# Georgia Institute of Technology

March 21, 1994

Mr. Marvin M. Mendonca, Senior Project Manager  
Non-Power Reactors and Decommissioning Project Directorate  
Division of Operating Reactor Support  
Office of Nuclear Reactor Regulation  
U.S. Nuclear Regulatory Commission  
Washington, D.C. 20555-0001

This is in response to your letter dated March 3, 1994, concerning the conversion of the GTRR from High-to Low-enriched uranium fuel. The answers to the questions follow. The answer to Question #1 is answered by me. The answers to the other Questions were provided by Dr. Woodruff of ANL.

Fig. 6. Thermal Conductivities of Uranium Silicide- and  $U_3O_8$ -Aluminum Dispersion Fuels as a Function of Volume Fraction of Fuel Plus Voids (Porosity).

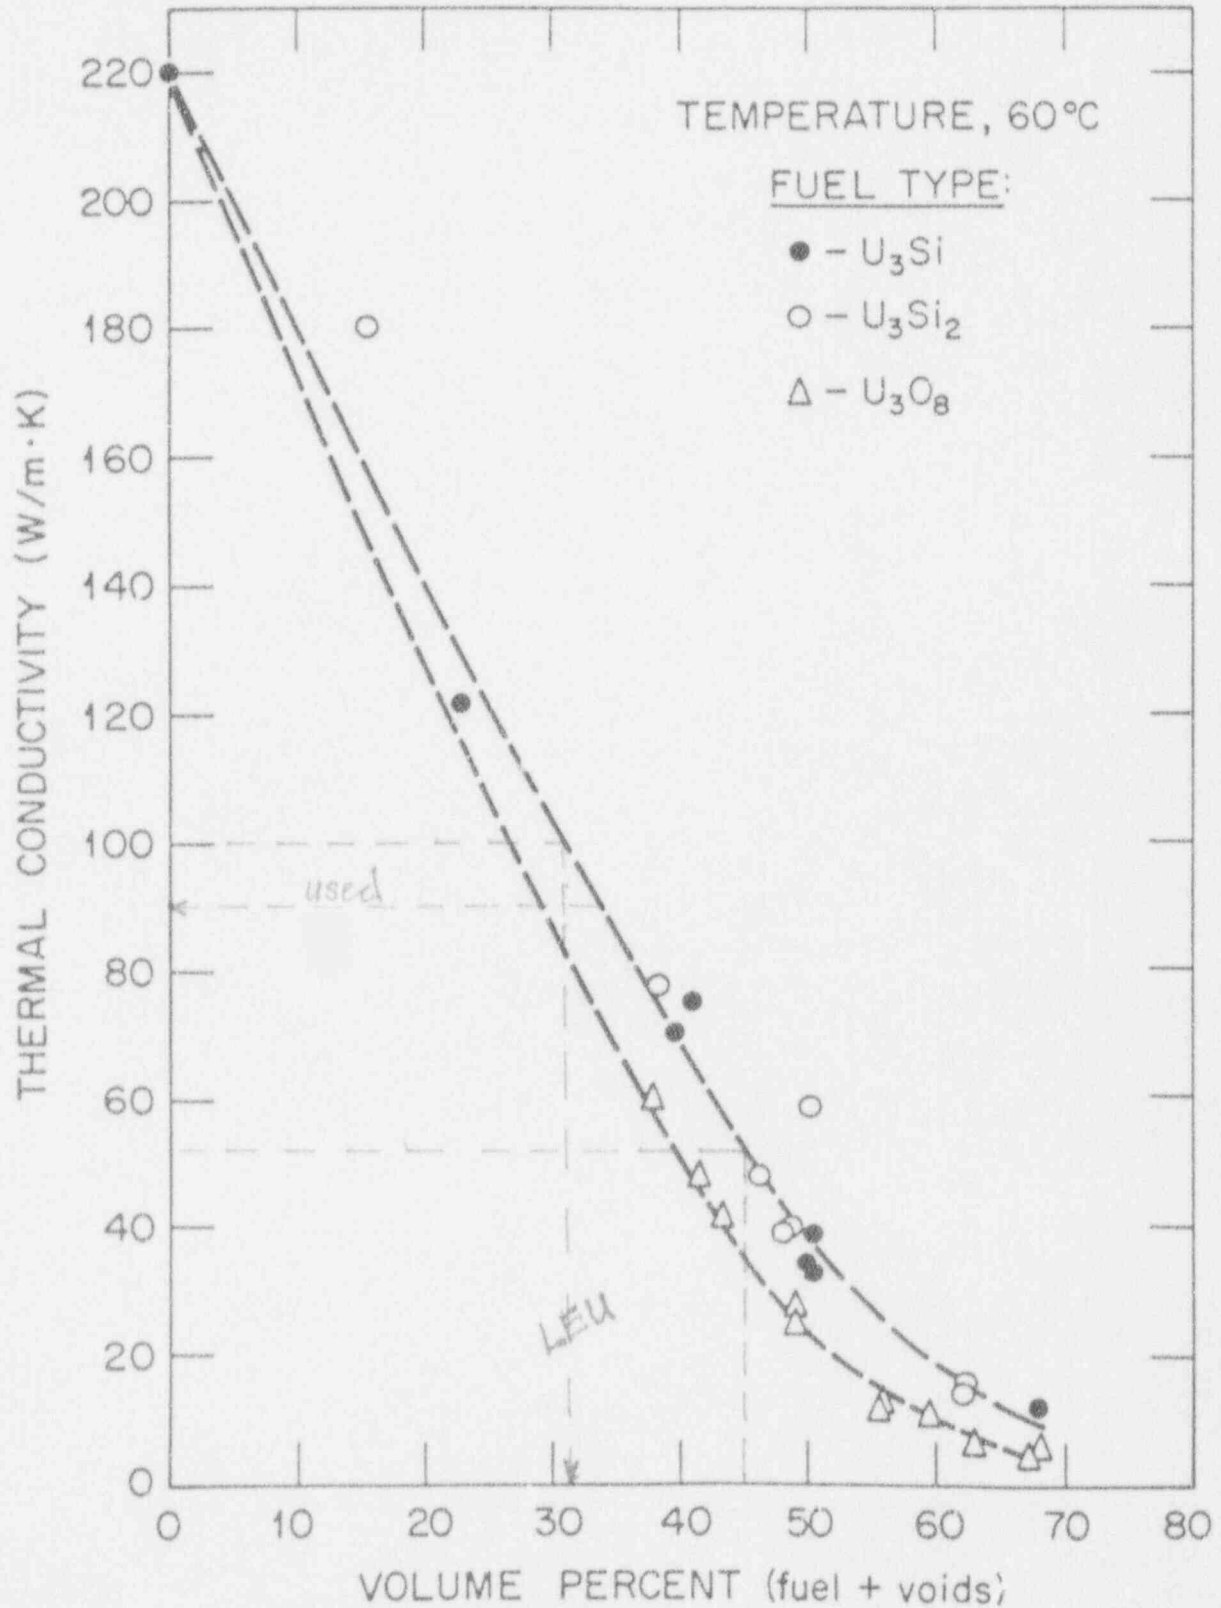
In Item 2A, both numbers are correct. The number from page 6 in NUREG-1313 is for silicide fuel with a volume fraction of 0.45, while the LEU fuel specified for the GTRR has a volume fraction of only 0.31. A figure is enclosed from Appendix A of NUREG-1313 that shows that at 31% the thermal conductivity is about 100 W/mK (a more conservative number of 90 W/mK was used to allow for uncertainties). In Item 2B, the cladding material is not pure Al but rather a 6061 alloy whose conductivity is about 180 W/mK (104 Btu/hr-ft-F).
